PL202100216

PL2021-216

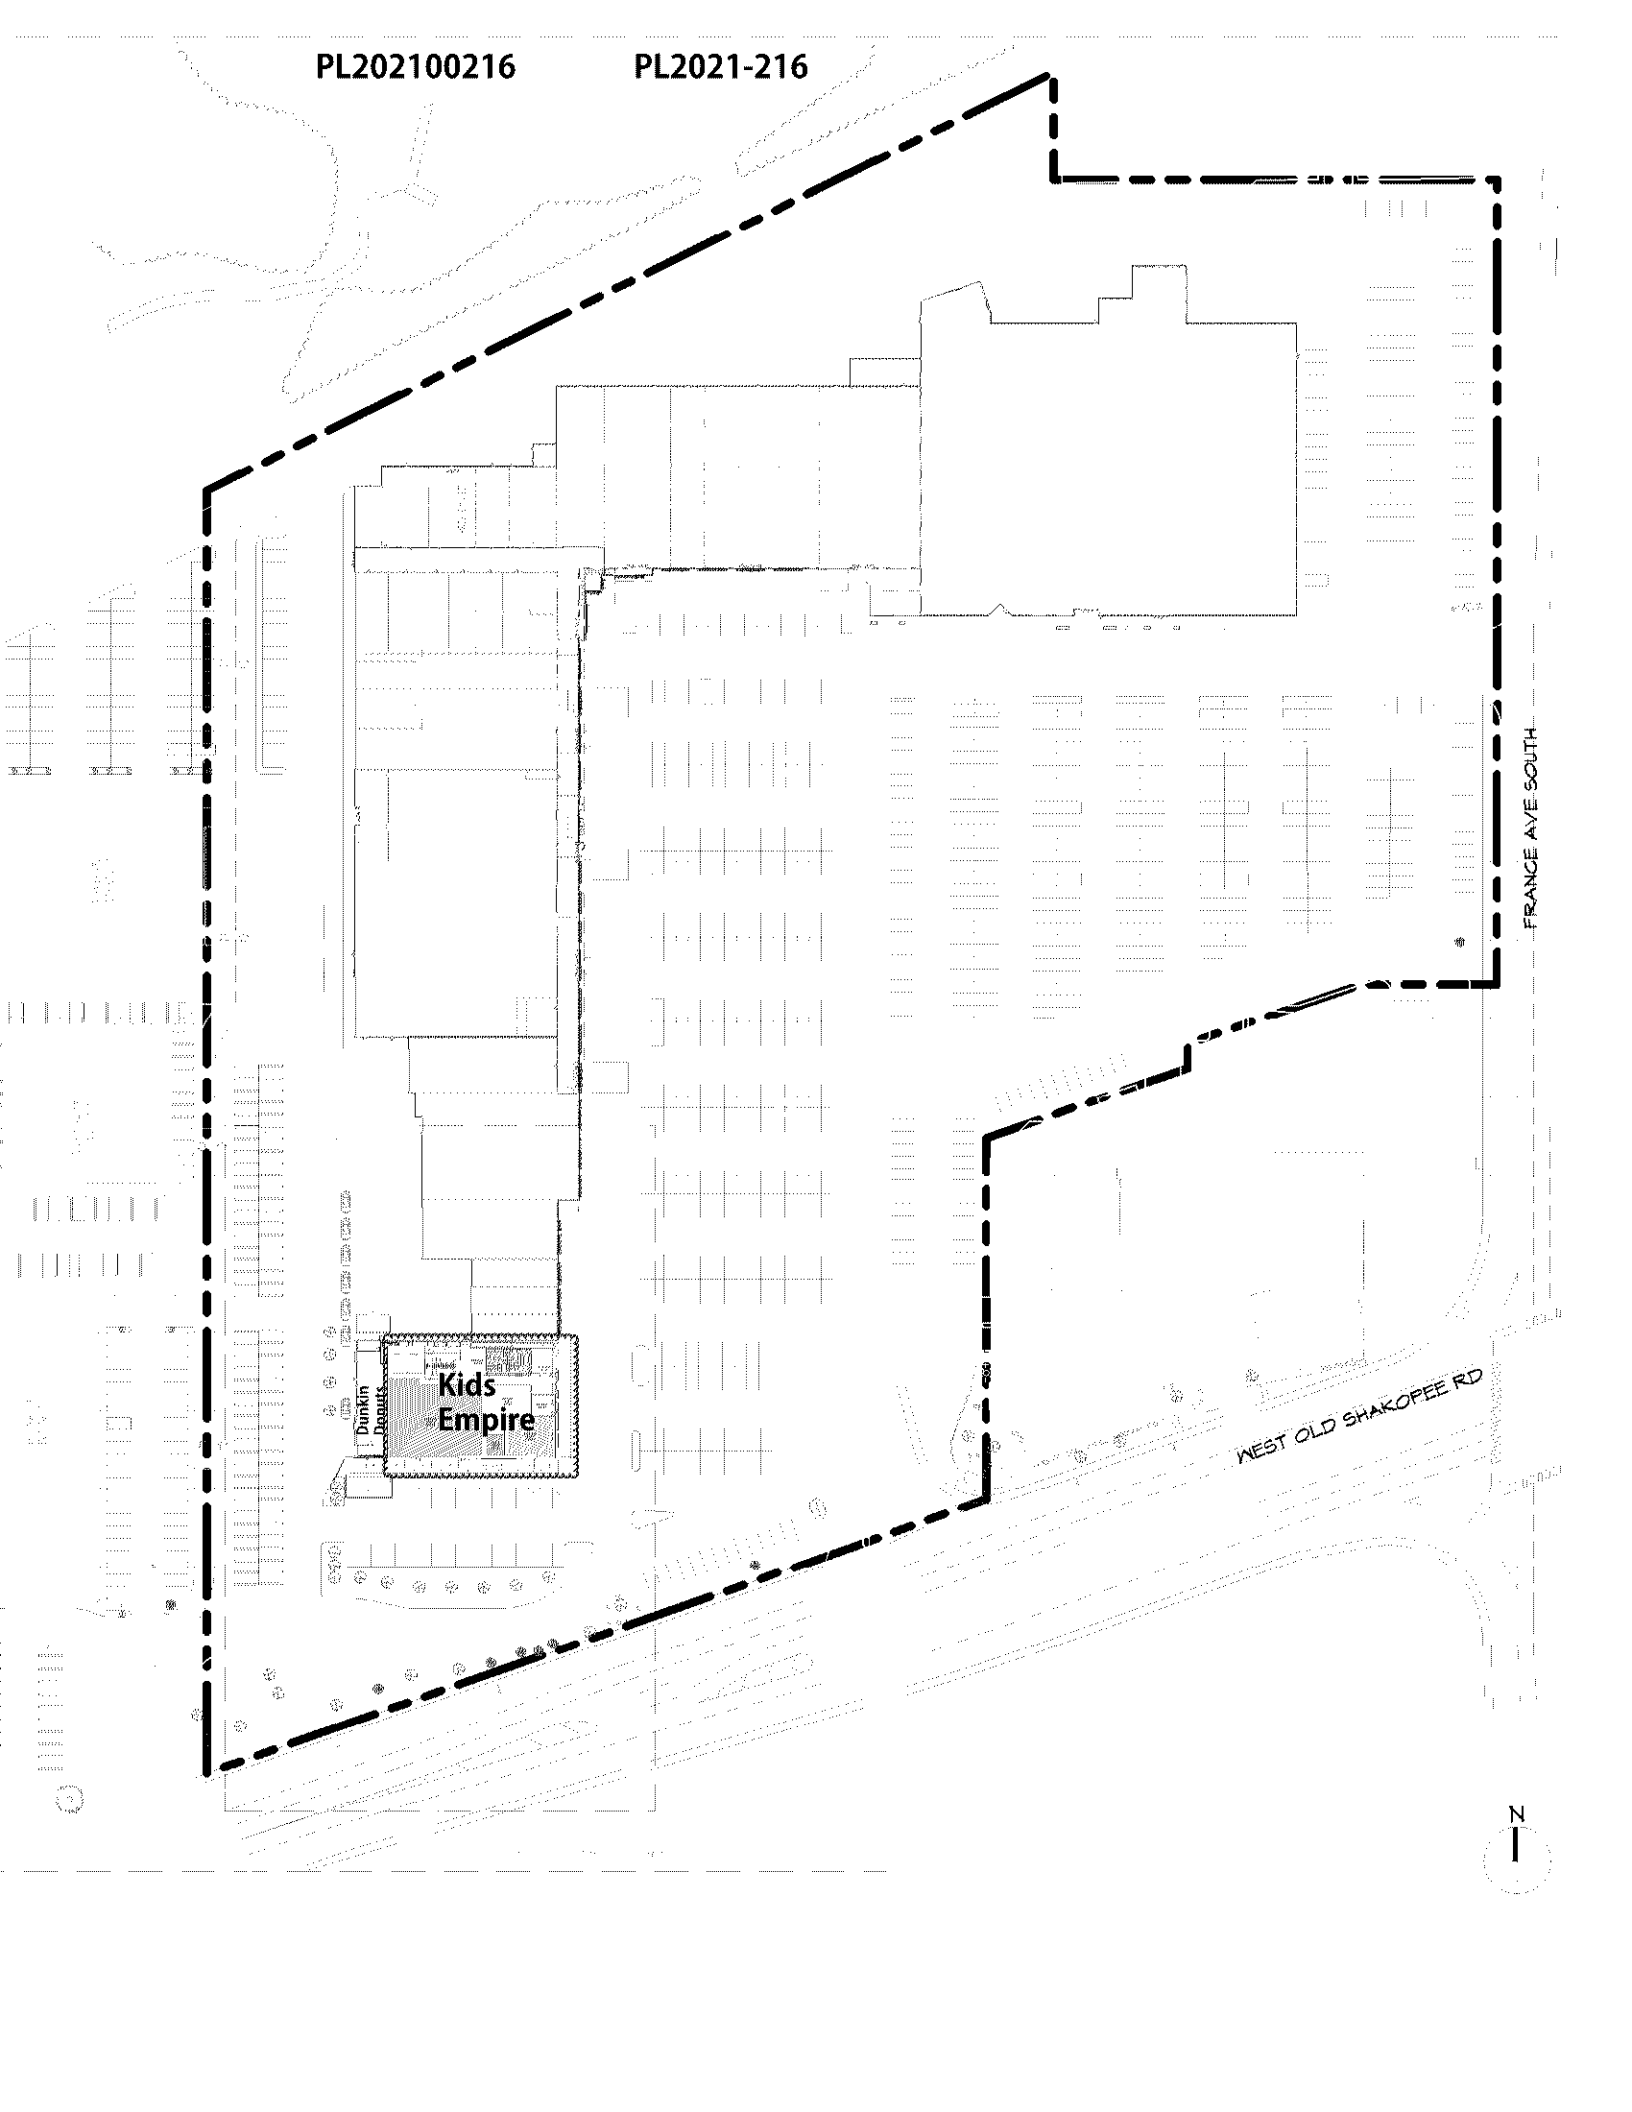
Provide specification sheets along with proposed menu with Plan review application.

Show bike parking racks that are within 50' of main entrance. If none, add.

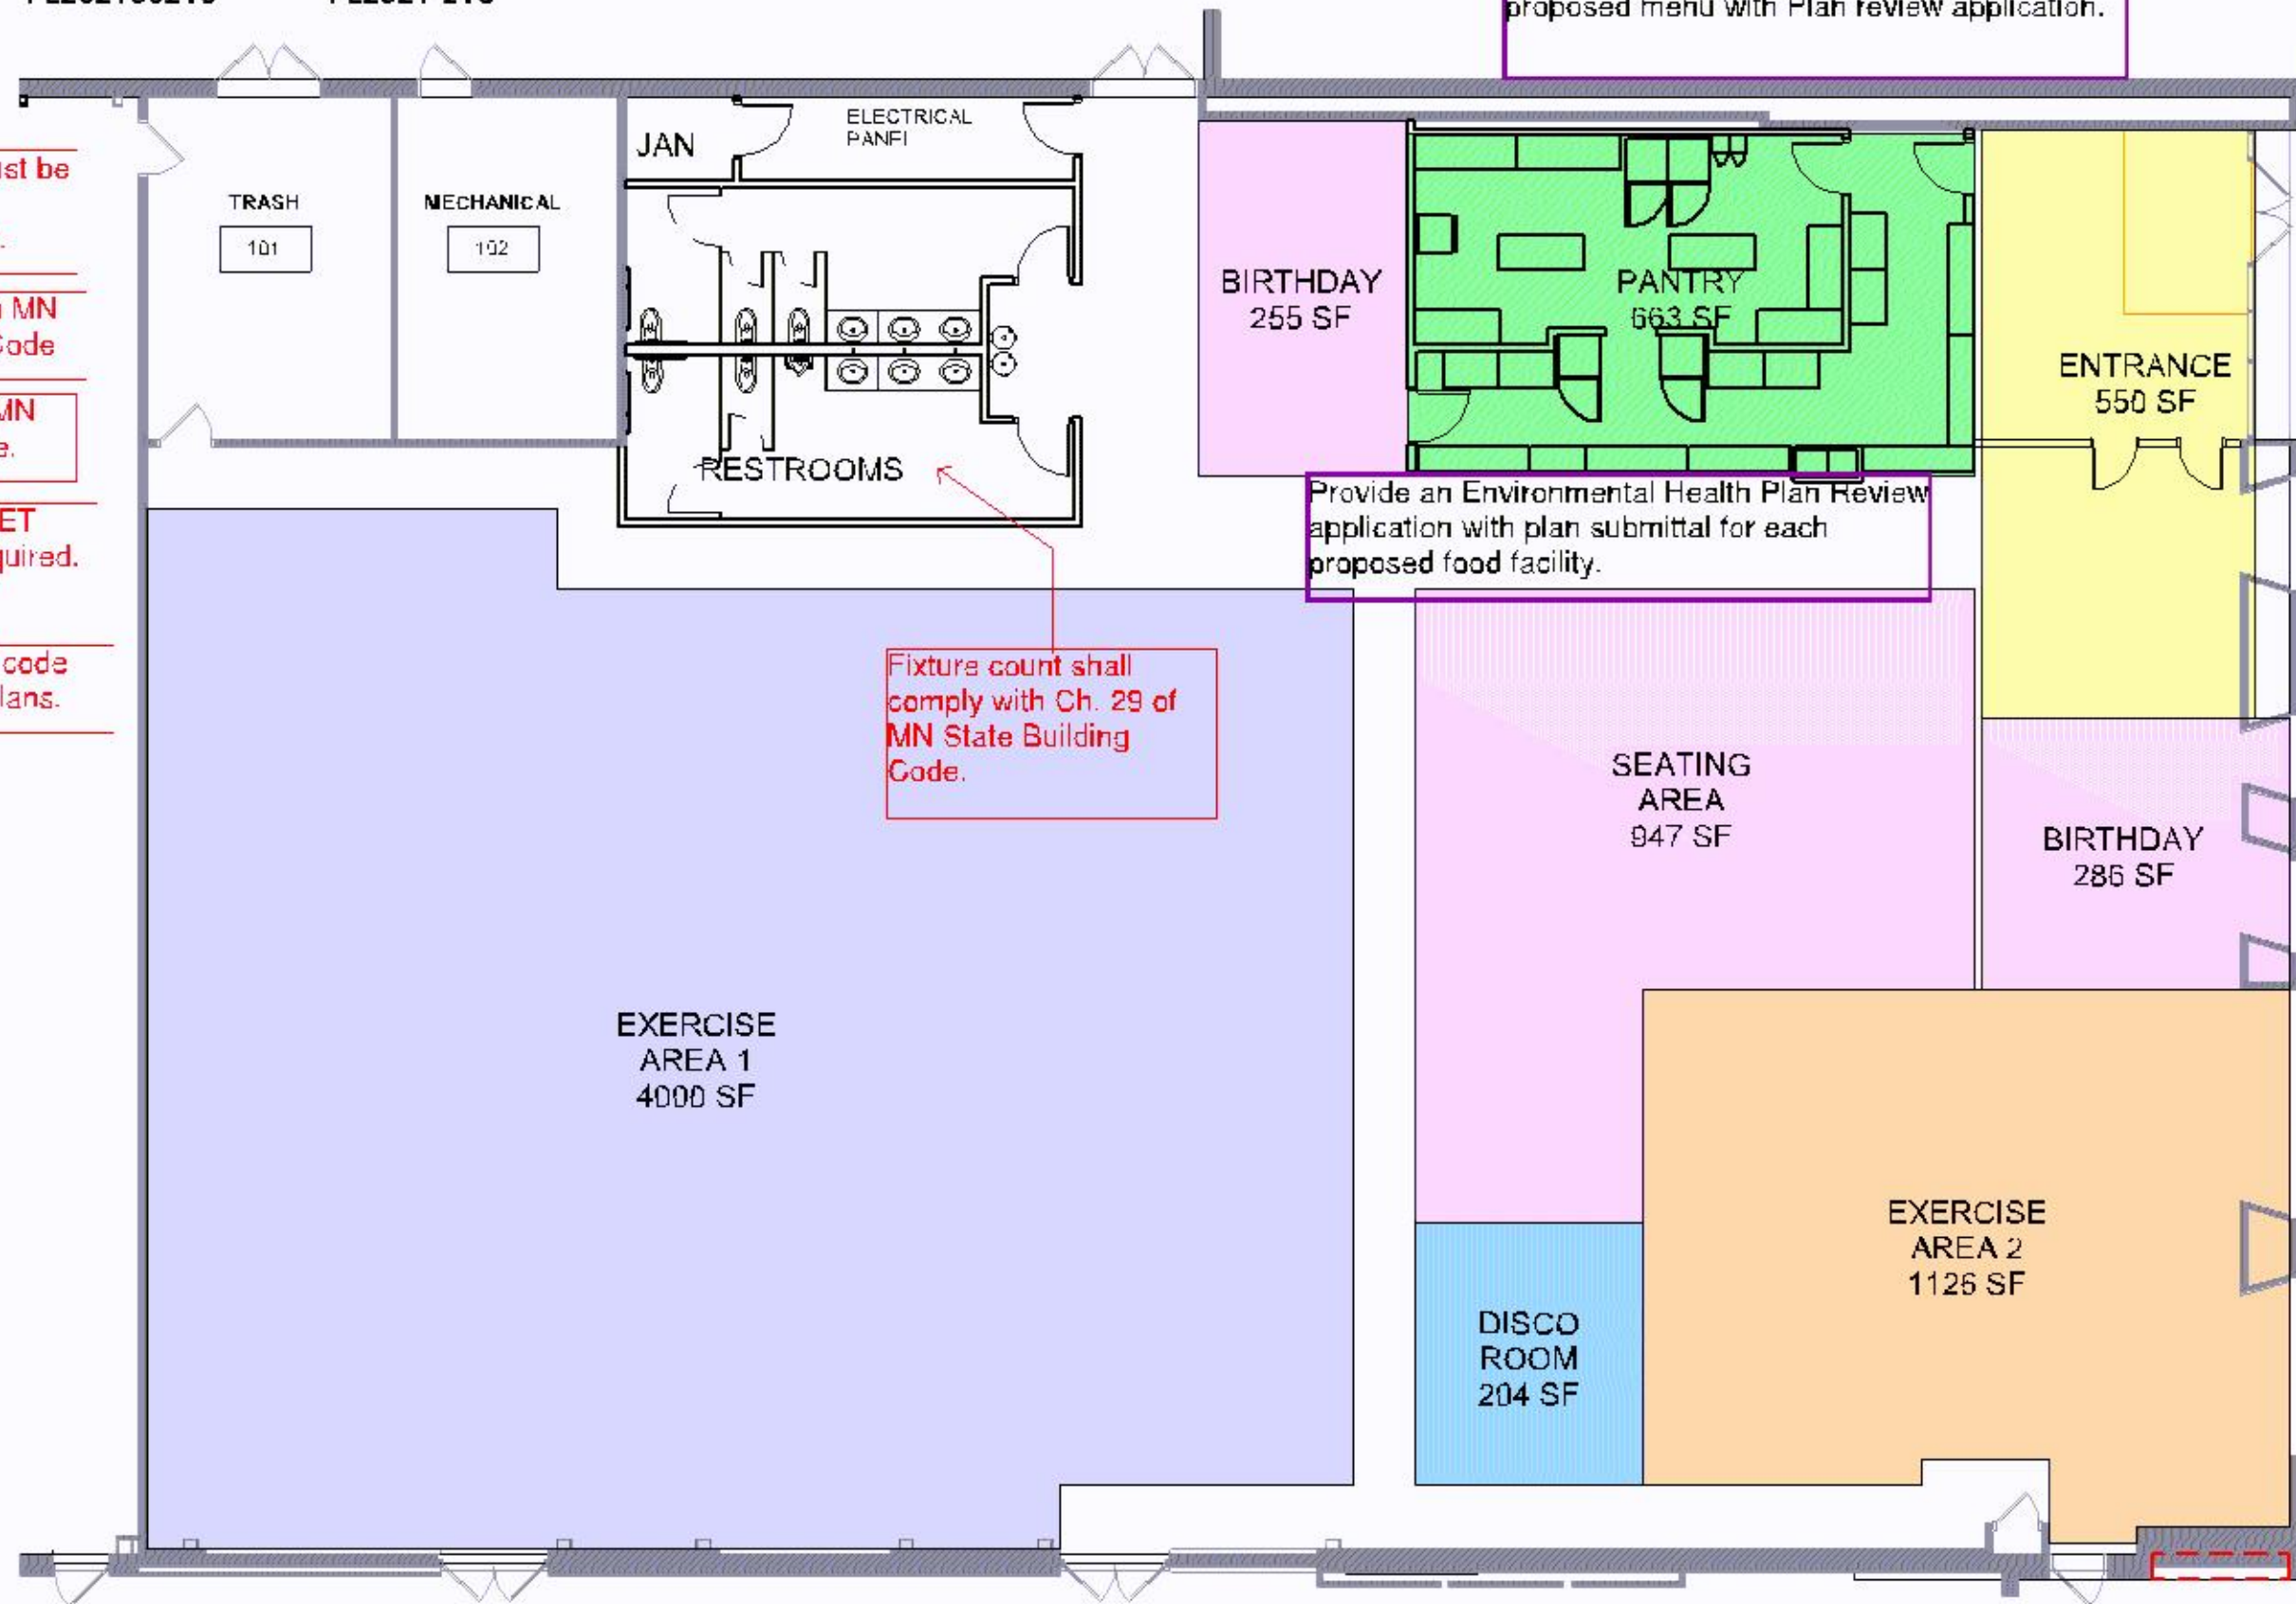
Building plans must be signed by a MN licensed architect.

Must meet 2020 MN State Building Code

Must meet 2020 MN Accessibility Code.

SAC review by MET council will be required.

Provide a detailed code analysis with the plans.

Fixture count shall comply with Ch. 29 of MN State Building Code.

Provide an Environmental Health Plan Review application with plan submittal for each proposed food facility.

Fire alarm system will need to be upgraded for the occupancy classification determined by the building code.

Ensure proper sprinkler coverage and density for the additional commodity hazards in the exercise area.
